SAFETY EVALUATION
PILGRIM NUCLEAR POWER STATION

Description of Proposed change, test, or experiment: Evaluate results of a design
verification for safety related cooling systems using the FSAR site maximum salt
service water temperature of 75°F. Revise the FSAR to reflect the analysis results.
Revise Technical Specification Bases 3/4.7.A regarding local suppression pool
temperature limits (See Attachment C for markup).

Comments: This safety evaluation revises the suppression pool temperature
bases for TS 3.7.A. See "Analysis of Effect on Safety Functions" in Att. A.

FIGURE 4.8-3

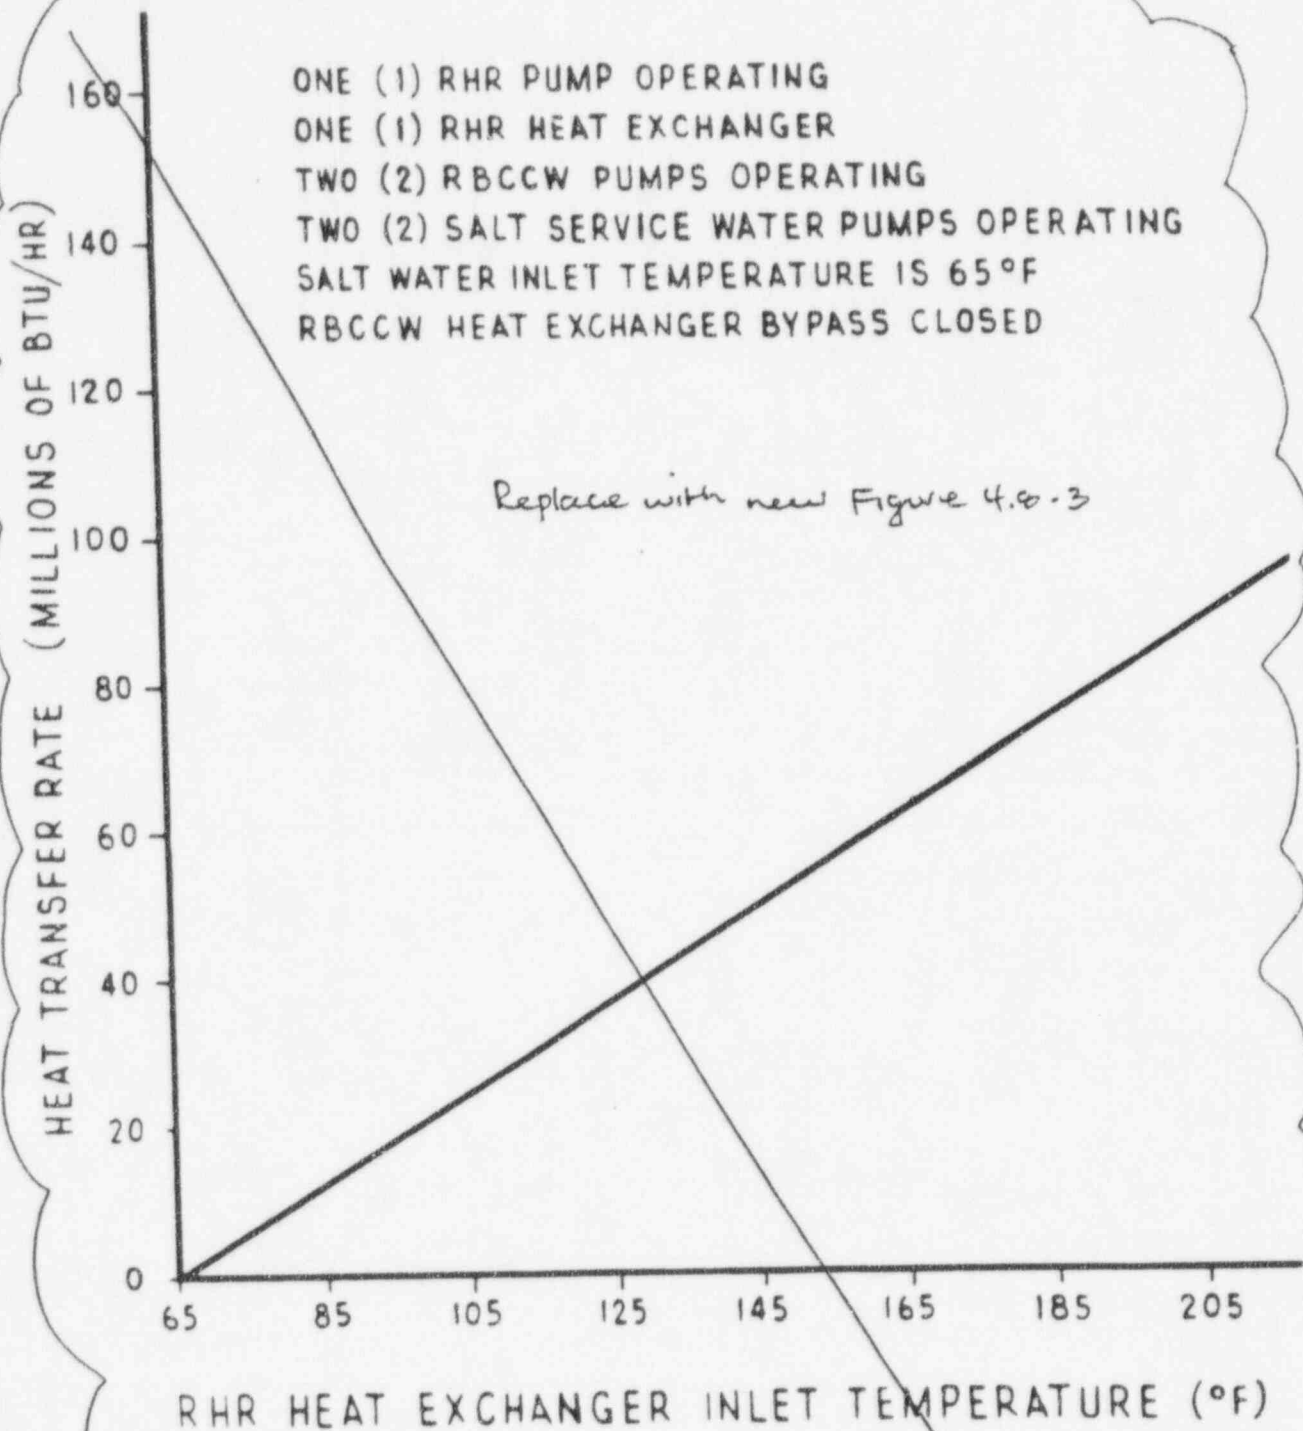
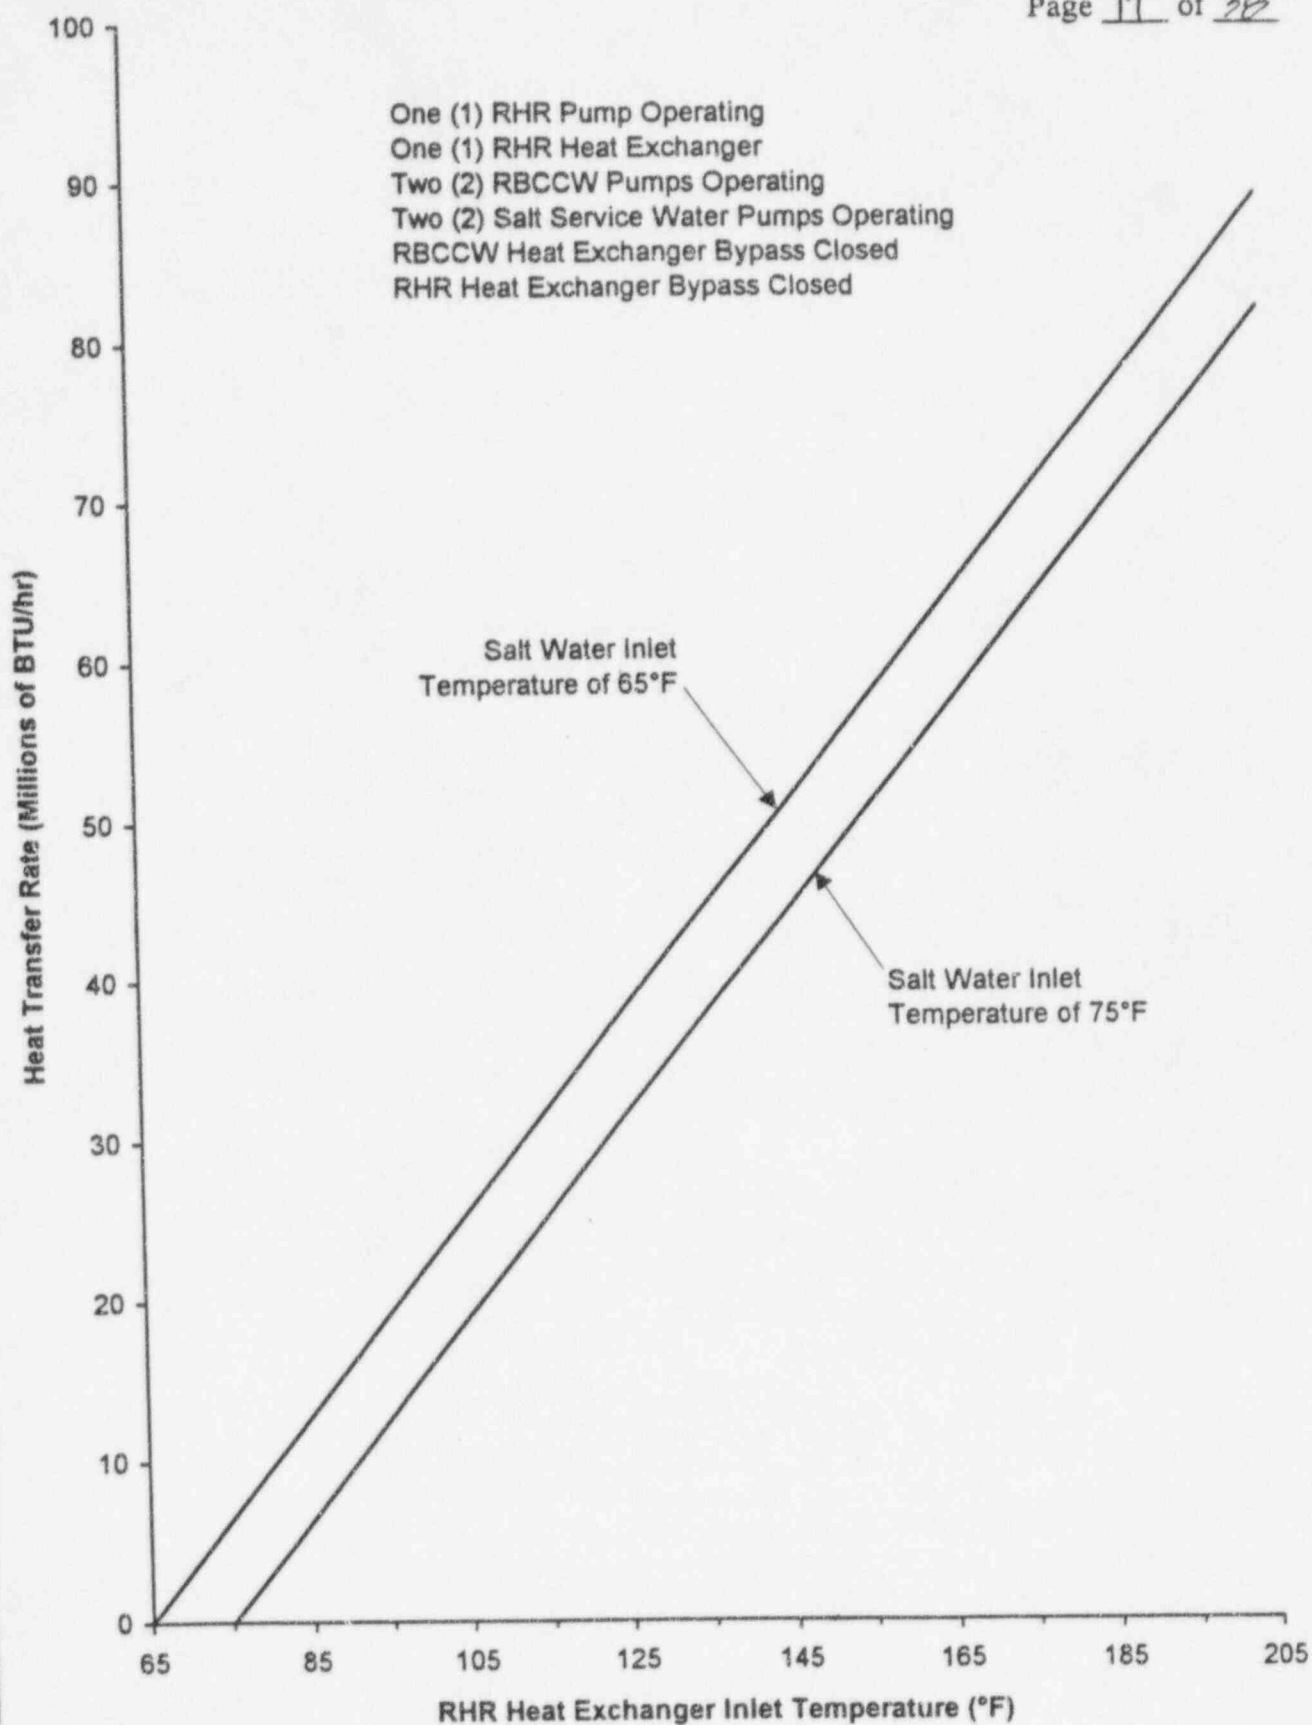
7. Replace Figure 4.8-3 "Residual Heat Removal System Heat Transfer Capability" with attached curve.

The new curve adds 75°F capability curve for RHR heat exchanger on Figure 4.8-3.

Figure 5.2-19. NRC Specified Local Pool Temperature Limit Based on NUREG-0783 for P11G1m

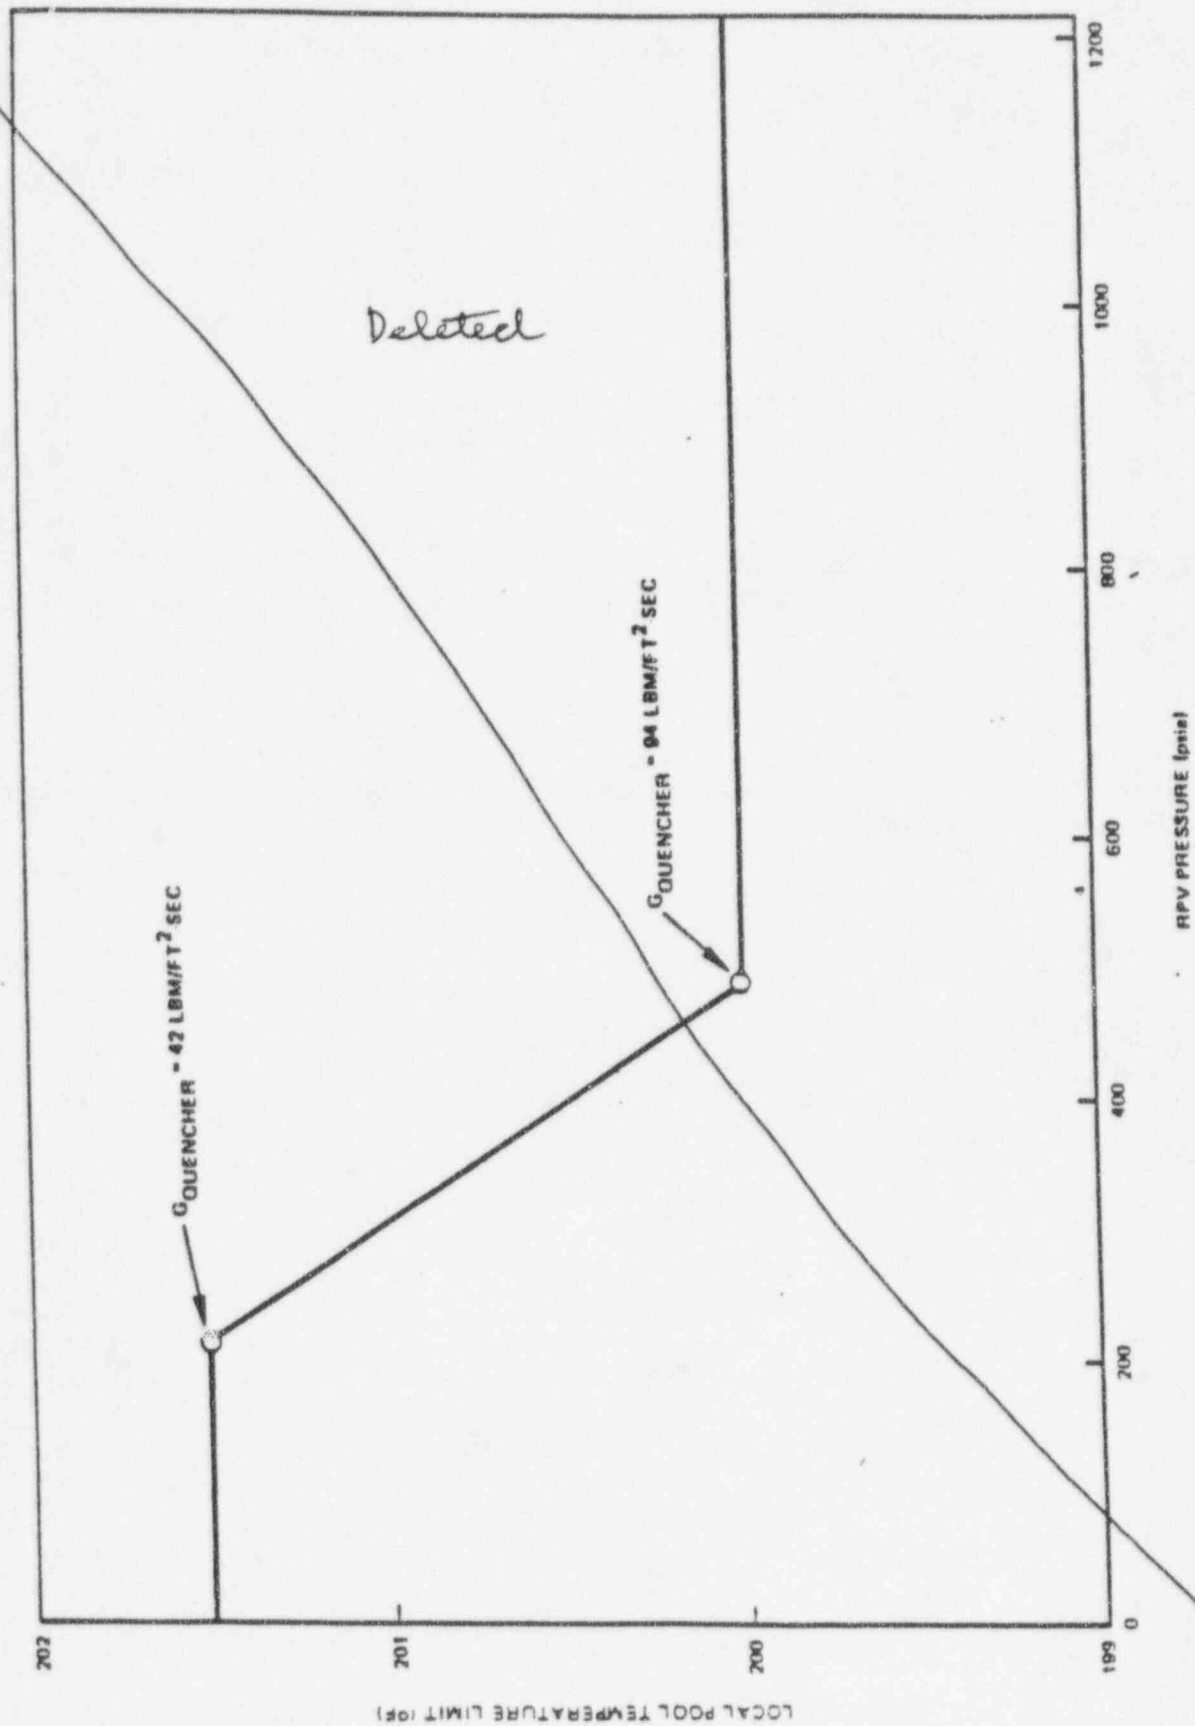
The proposed bases change removes reference to local pool temperature limits and removes reference to the associated 160°F bulk suppression pool temperature limit.

9. Revise 5.2.4.10 Primary Containment Steam Quenching

Technical specification limits on bulk suppression pool temperature ensure effective steam condensation during a LOCA or SRV discharge. The water temperature in the vicinity of the SRV discharge to the suppression pool is referred to in design and licensing documents as the local pool temperature. During plant transients and accidents involving SRV actuation, the suppression pool temperature is elevated by steam discharged from the primary system to the suppression pool through the relief valve discharge line. Past experimental data and plant experience indicated the potential for unstable steam condensation during safety-relief valve (SRV) operation at elevated pool temperatures (Reference 2) related to high water temperature near the SRV discharge. The unstable condensation process in a heated pool was observed to cause cyclical pressure loads on the pool boundary and structures inside the wetwell.

Figure 14.5-16 Design Basis Loss of Coolant Accident - Containment Pressure Response
75°F SSW Case

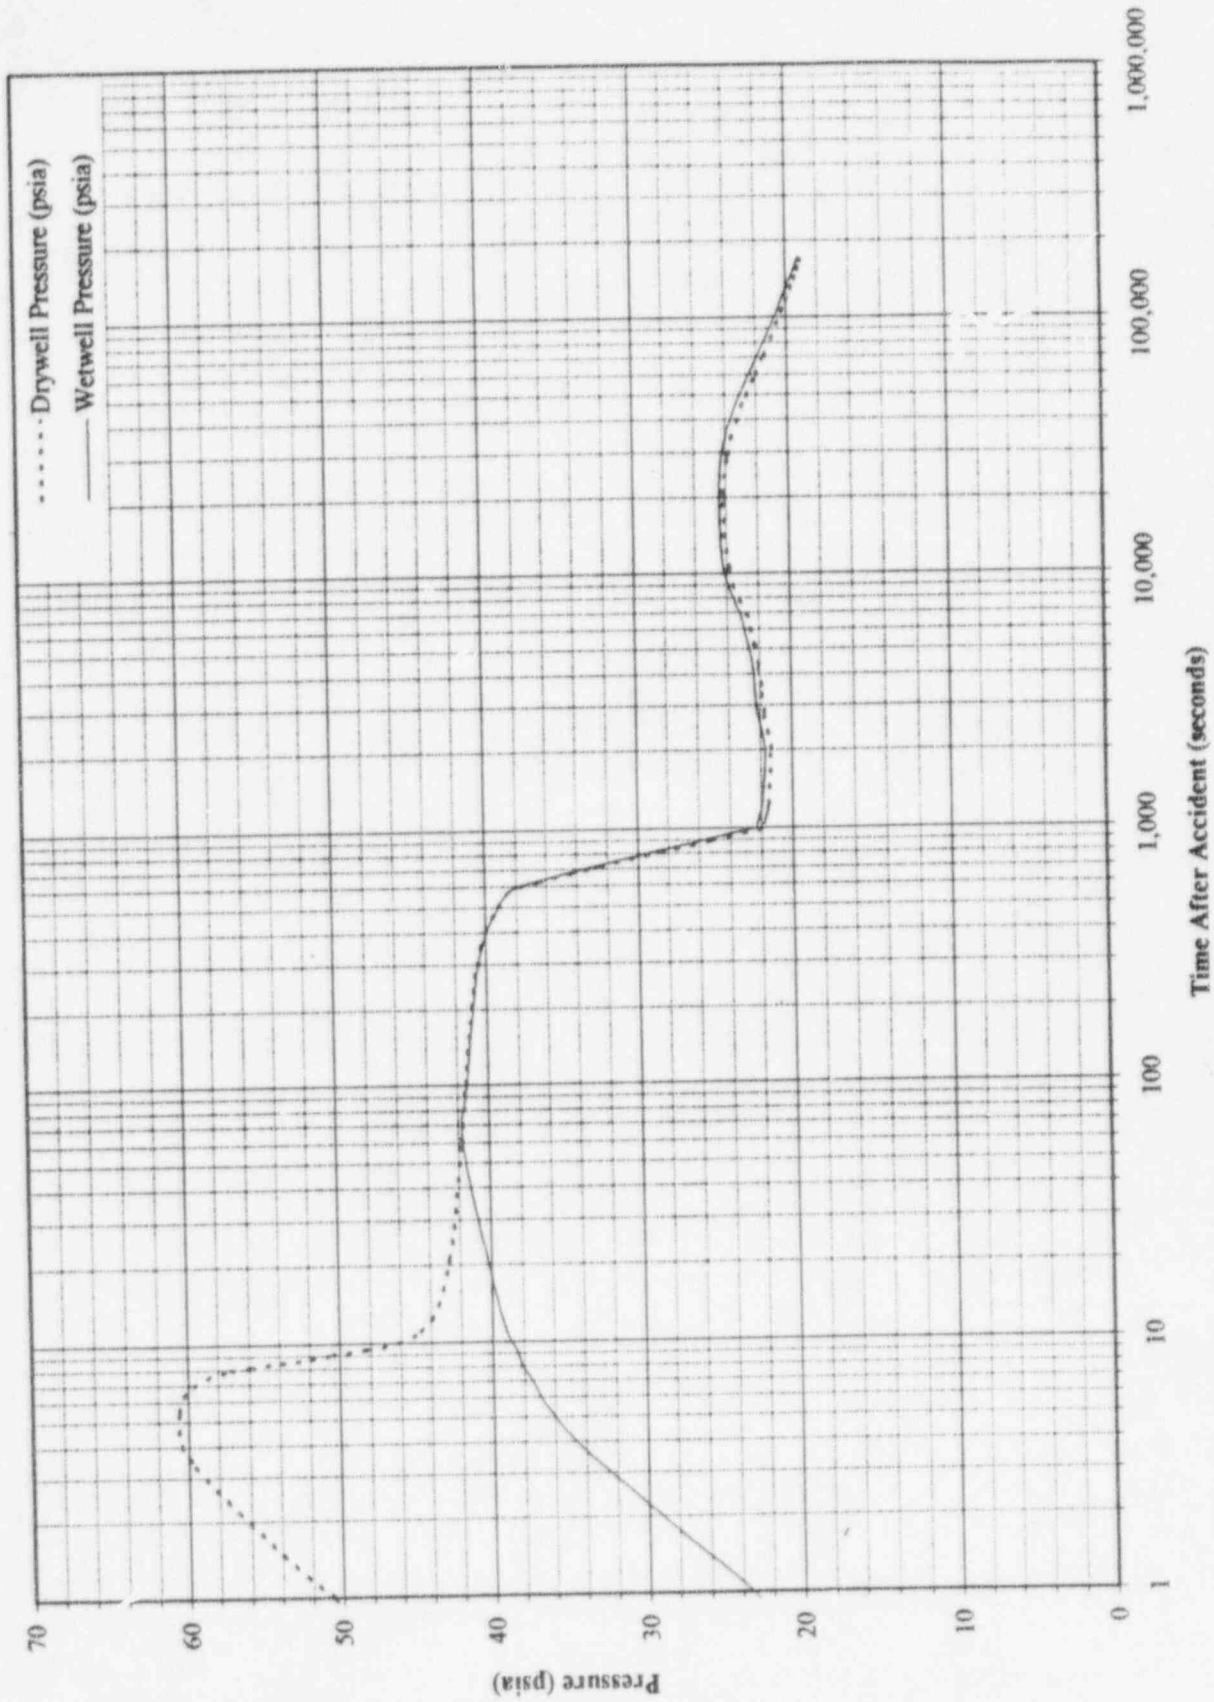
For the 75°F SSW Case, the calculated pressure and temperature responses of the containment are shown on Figures 14.5-16, and 14.5-17. The short-term response of the drywell, wetwell, and suppression pool is the same as for the Case B from the 65°F SSW Case. The containment response prior to 600 seconds is unaffected by containment cooling and remains the same for both cases. The 65°F SSW Case provides additional description of the short-term response.

18. **Add new Table 14.5-2 [see attached]**
19. **Add new Figures 14.5-16, 14.5-17, 14.5-18, 14.5-19 [see attached]**
20. **Replace Section 14.5.3.1.3 "Core Standby Cooling System Pump Net Positive Suction Head" with the following [see markup]**
